WILLIAMSON COUNTY, TEXAS

CHANGE ORDER NUMBER: 3

Project:	<u>1603-062</u>
Roadway:	<u>CR 258</u>
CSJ Number:

Change Order No. 3

RECONSTRUCTION OF COUNTY ROAD 258
CR 258
PLAN AND PROFILE
STA. 149+00 TO STA. 153+00
SHEET 21 OF 24

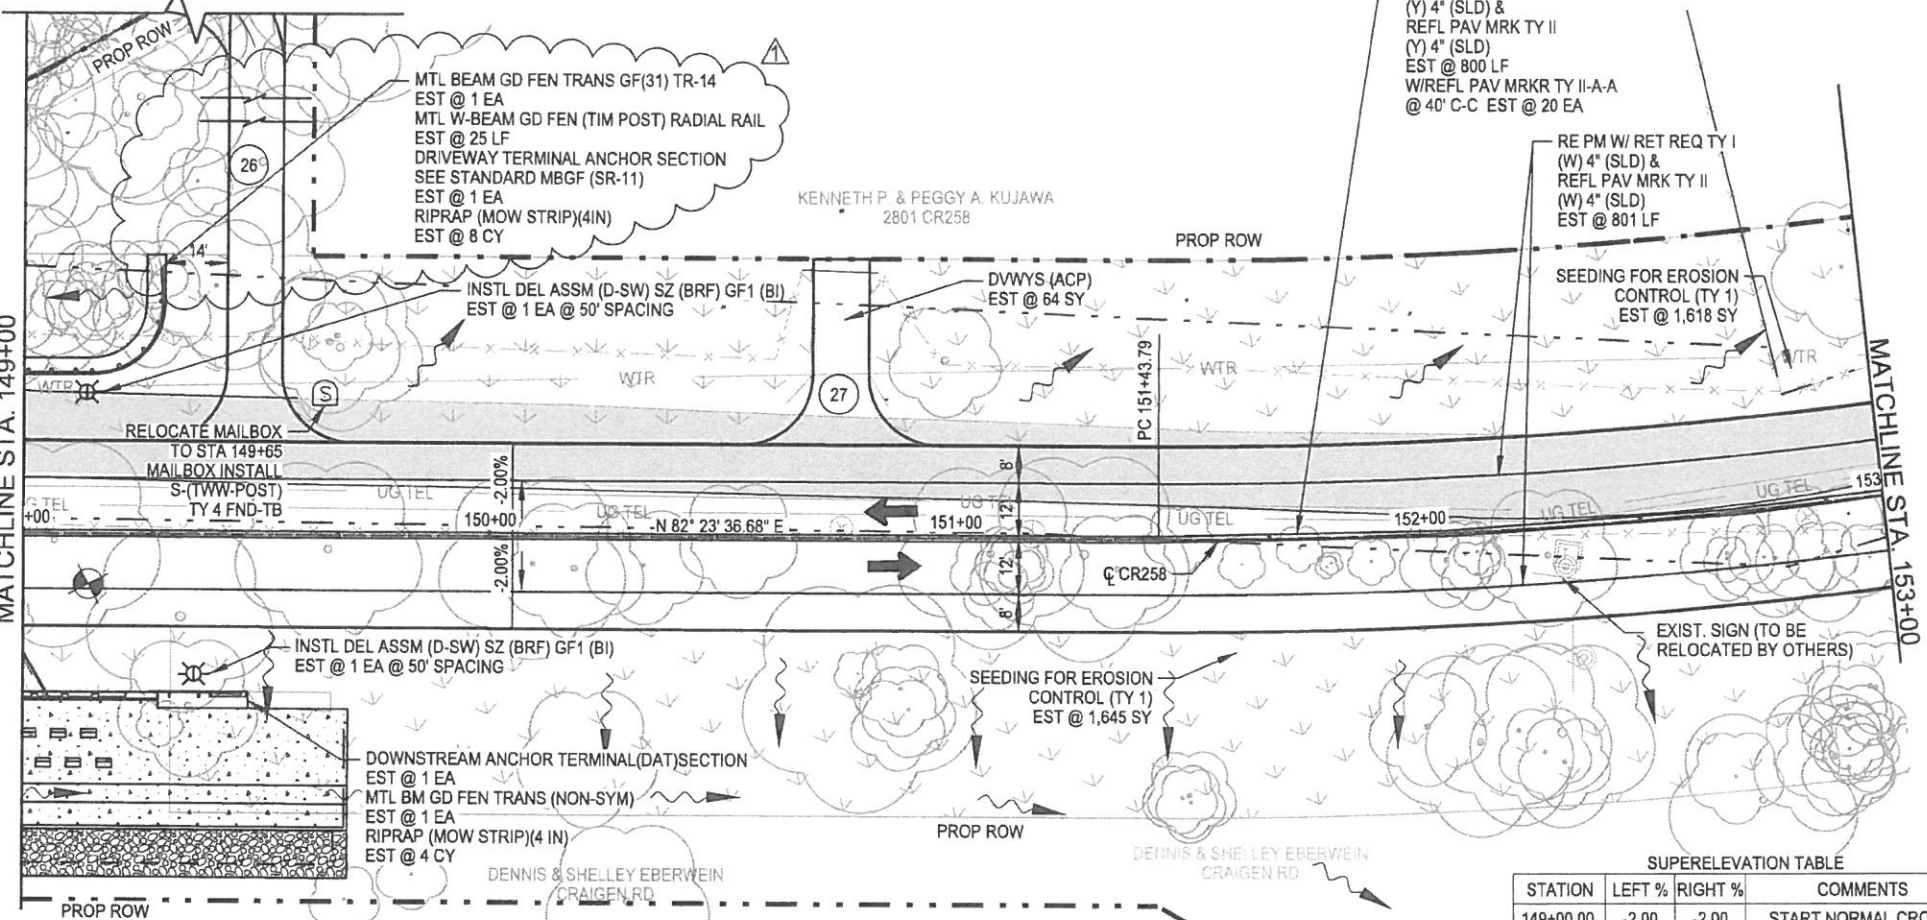
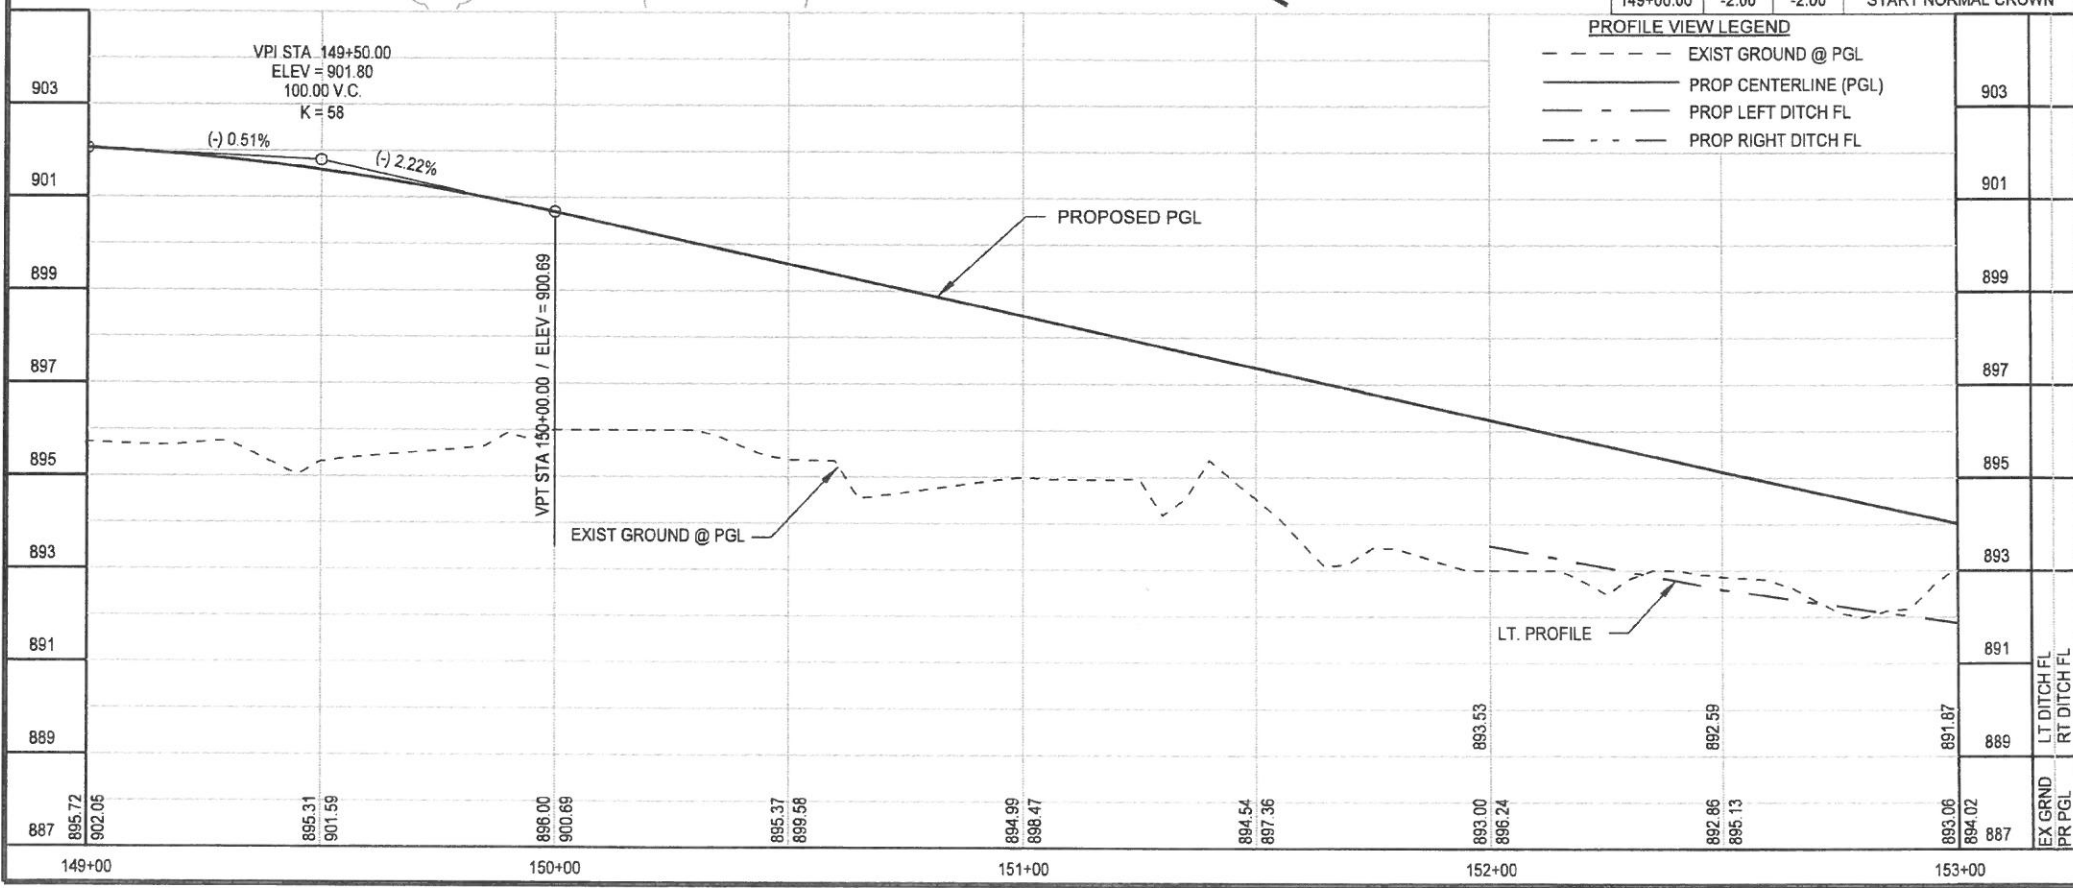
Proposed MBGF was shortened at Driveway 26, to keep the proposed guardrail (MBGF) within the ROW limits like Driveway 25A.

ADJUSTMENT TO MBGF AT DRIVEWAY 26.

"DRIVEWAY" TERMINAL ANCHOR SECTION

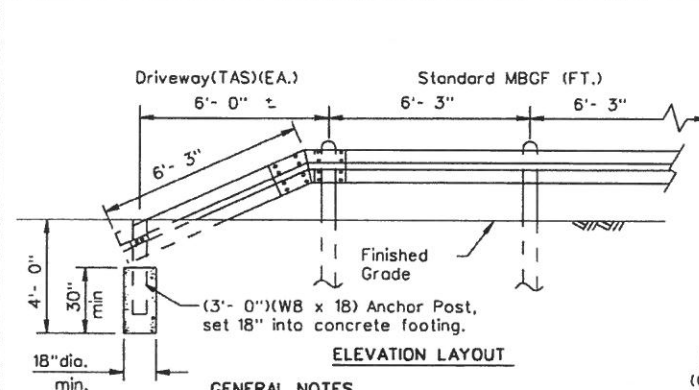
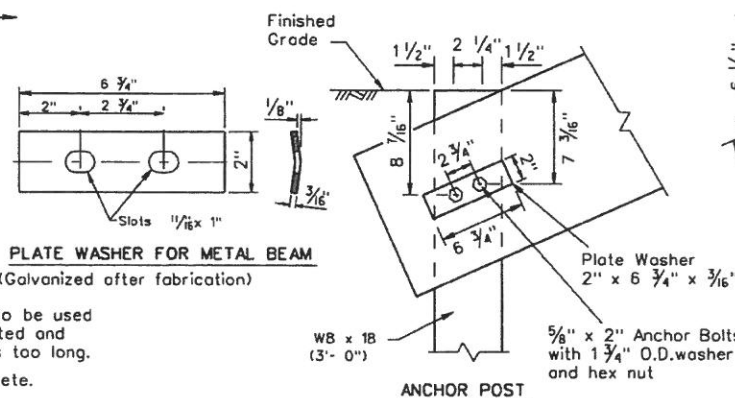
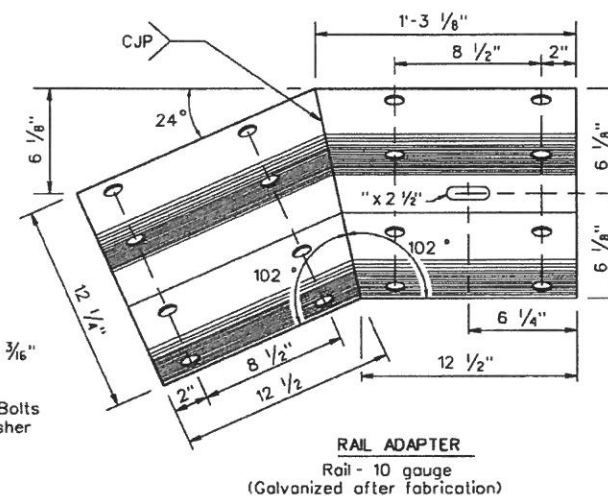
▲ STANDARD ADDED TO THE PLANS.

1. The "Driveway" Terminal Anchor Section is ONLY to be used within driveway locations, where the ROW is limited and a standard 25 ft. (TAS) Terminal Anchor Section is too long.
2. Terminal anchor post shall be set in Class A concrete.
3. All steel shall be galvanized after fabrication in accordance with Item 445, "Galvanizing."
